802.3dj D2.0

Comment Resolution

Electrical Track

KR Link Diagram

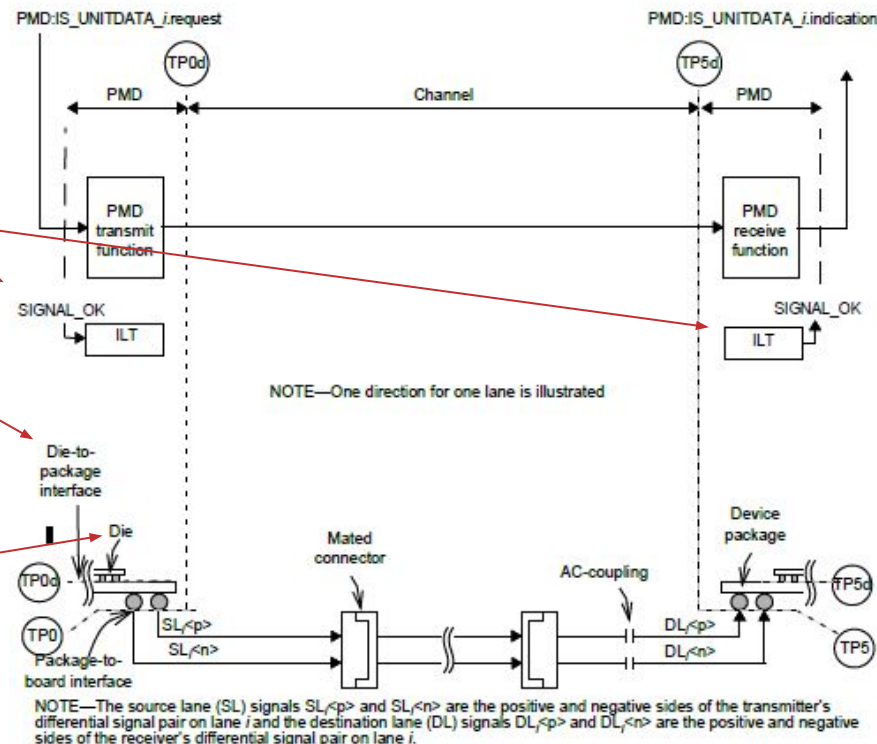
In Figure 178-2 add the ILT function above the PMD transmit and receive functions. Show the SIGNAL_OK as an input to the ILT function at the left side and as an output to the ILT function in the right side (refer for example to Figure 180-2)

Figure 178-2. The interface at TP0 is helpfully labelled as "package-to-board interface". A similar label would be helpful at TP0d.

In Figure 178-2, make the following changes:

Show the PMD ending and "channel" beginning at TP0 and TP5.

Add a label at TP0 and TP5 "MDI".

Change label pointing to the die on the left side of the Figure 178-2 to "Die".

Proposed changes to 178.8.1/Figure 178-2.

- 92: Add the ILT function & SIGNAL_OK above PMD function.
- 302: Label “Die-to-package interface at TP0d. Also apply to Figure 176C-2.
- 303: Show channel going from TP0 to TP5. Add “MDI” at TP0 & TP5. (and in Figure 176C-2)
- 304: Change label on die at left from ‘device’ to ‘die’.
- 640: Change subclause title. Add sentence to 1st paragraph stating that the PMD is specified at TP0v & TP5v.
 - Note: the MDI is specified at TP0 & TP5 (ref 178.11).

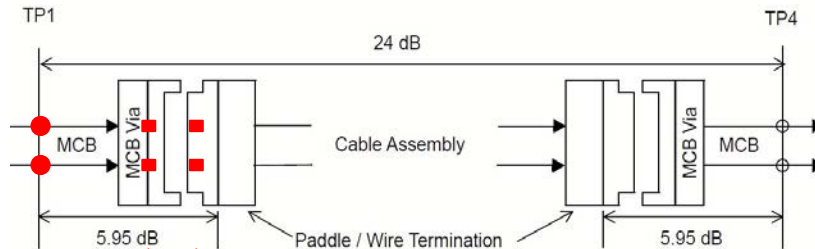
This comment is specifically about the span of Tfx in a cable assembly test fixture (aka MCB).

This comment seems to address both MCB and HCB.

Figure 176D-5—Module compliance points

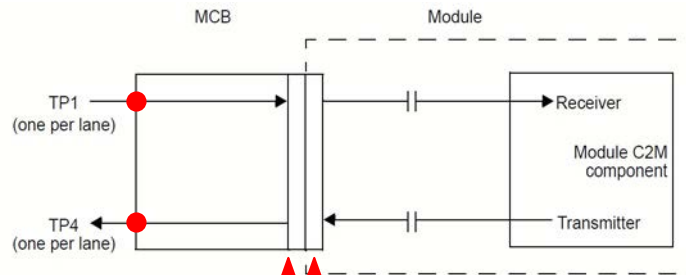
- A: MCB connector pads
- B: Receptacle mating point (Cable/HCB pads/Gold Fingers)
- C: Somewhere else?

(Top of Figure 179A-1)

CR Test Fixture Comments 658

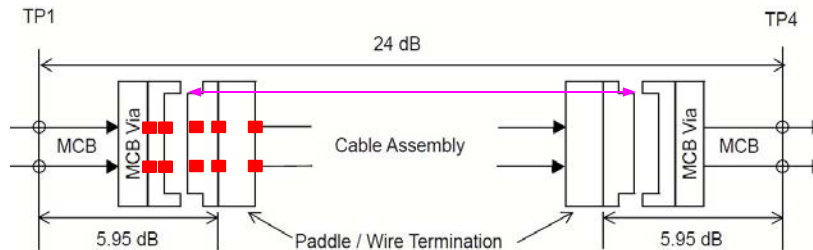
- Is the text “Paddle / Wire Termination” in the Figure clear, and useful?

(Top of Figure 179A-1)

CI 179A	SC 179A.5	P 821	L 4	# 658
Swenson, Norman		Nokia, Point2		
Comment Type	TR	Comment Status	D	(Electrical) CR test fixture
What is the extra rectangle labeled Paddle/Wire Termination shown in Fig. 179A-2 that is not shown in the mated test fixtures in Fig 179A-1? It is not explained in the text.				
Suggested Remedy				
Clarify				
Proposed Response	Response Status W			
PROPOSED ACCEPT IN PRINCIPLE.				
The rectangle and labels "Paddle/Wire Termination" serve as demarcation of the cable assembly and the host channel, in Figures 179A-1, 2, and 3. The "Paddle" and "Wire Termination" are structures associated with the cable assembly, and are not necessarily present in an HCB (or Mated Test Fixture). The labels are used to identify specific structures that are not documented elsewhere in the figure.				
These figures provide illustration as appropriate within an informative Annex. Similar figures with the same features are included in in Annex 162A, added by IEEE Std 802.3ck.

The suggested remedy does not contain sufficient detail for the CRG to discuss a specific change.

CR Test Fixture

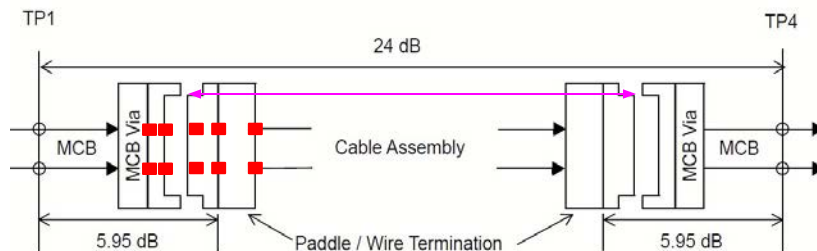
MCB connector pads
MDI receptacle interface
Receptacle mating point
(Cable / HCB pads / Gold Fingers)
Ambiguous Test Point
Paddlecard / DAC wire termination

(Top of Figure 179A-1)

CI 179A	SC 179A.5	P 820	L 39	# 289
Heck, Howard		TE Connectivity		
Comment Type	TR	Comment Status	D	(Electrical) CR test fixture
<p>MCB loss specified in the lower left of Figure 179A-1 is not directly measurable as it is currently specified. Indirect measurement methods do not provide the necessary accuracy. The version of the figure in D1.4 was measurable and reverting back to it will resolve the problem. Equation 179B-2 requires modification to make it accurately represent the MCB insertion loss measured with the 2Xthru method</p>

CI 179B	SC 179B.2.1	P 823	L 34	# 513
Dudek, Mike		Marvell		
Comment Type	TR	Comment Status	D	(Electrical) CR test fixture
The loss needs to be better defined to be less ambiguous.				
Suggested Remedy				
Insert the sentence "The cable assembly tested fixture loss is equal to the loss of the mated test fixture minus the loss of the specific TP2 or TP3 test fixture printed circuit board loss used when measuring the mated text fixture loss." between the 1st and 2nd sentences.				
Proposed Response		Response Status	W	
PROPOSED ACCEPT IN PRINCIPLE.				
The suggested remedy addresses the ambiguity in the definition of ILcatf, but introduces an additional ambiguity regarding the definition of ILtfref. As a result, the specification is not necessarily less ambiguous.				
Discuss with comment #289.				
[Editor's note: Changed Page from 823 to 824]
